STATE OF MAINE  
DEPARTMENT OF TRANSPORTATION  
16 STATE HOUSE STATION  
AUGUSTA, MAINE 04333-0016

September 29, 2022  
Subject: Ticonic Bridge Replacement  
State WIN:023138.00  
Location: Winslow & Waterville  
**Amendment No. 2**

Figure 1 – Limit of Contractor Winter Maintenance and Snow Removal at Two Cent Bridge

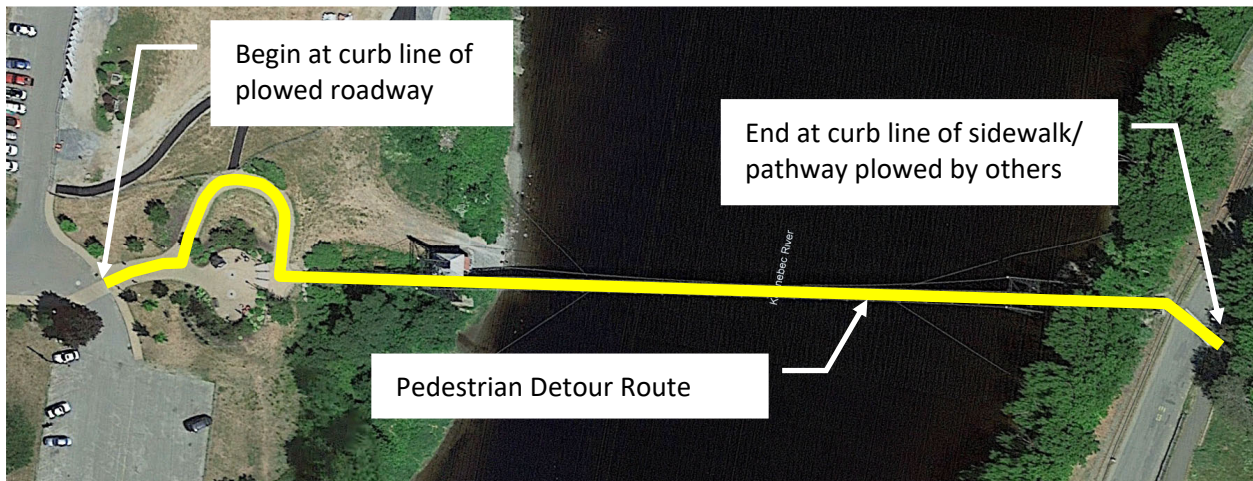
During periods when the Pedestrian Detour using the Two Cent Bridge is in place, the Contractor shall provide for, and perform, all winter maintenance and snow removal in compliance with this Special Provision and within the limits shown in Figure 1. This work also includes the satisfactory removal of existing snow and ice from within the limits shown in Figure 1 prior to the implementation of the Pedestrian Detour using the Two Cent Bridge.

- a) The Contractor is responsible for snow removal/ice treatment at all times when Pedestrians are detoured to the Two Cent Bridge, regardless of whether the Contractor is actively working on site.

- b) The Contractor shall maintain an unobstructed width of five feet within the limits shown in the figure above.
- c) Within 12 hours of storm subsidence, and after the Municipalities have finished clearing the roadway, the Contractor shall clear and remove snow and treat for ice within the limits shown in Figure 1, including any windrows of snow left behind from adjacent snowplowing operations.

**Figure 1 – Limit of temporary walkway**

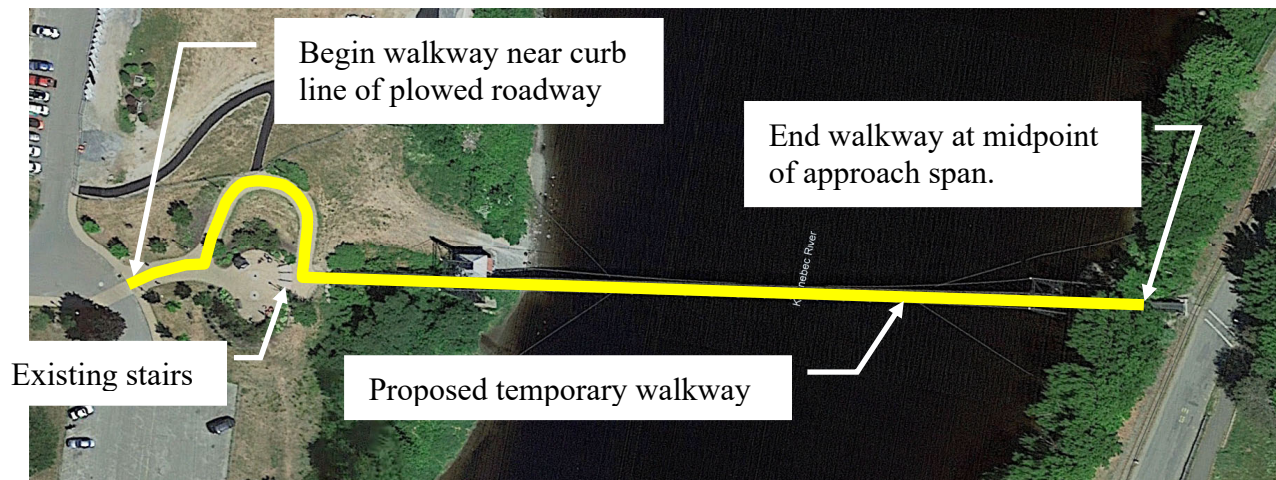
This work shall consist of constructing, maintaining, removing and reinstalling (if needed), and all labor, materials and equipment required to construct an ADA compliant temporary walkway along the identified portions of the pedestrian detour route for the purpose of preventing the underlying surfaces from being damaged by winter maintenance operations. The details and construction of the temporary walkway shall be as described herein. The limits and general layout of the temporary walkway shall be as shown in Figure 1. The temporary walkway shall be removed after each winter and reinstalled prior to the resumption of winter maintenance activities the following winter.

**Figure 2 – Conceptual cross section of temporary walkway**

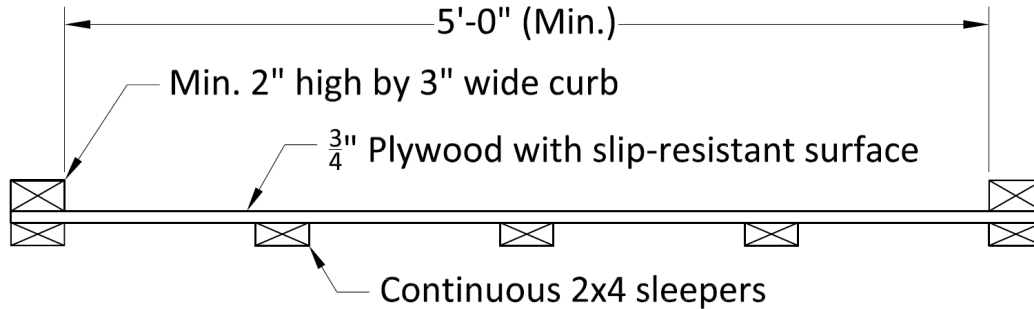
The typical section of the temporary walkway shall generally be as shown in Figure 2. The final geometry and details of the Temporary Walkway shall be determined by the Contractor and in accordance with the provisions stated herein. The following design and construction requirements apply:
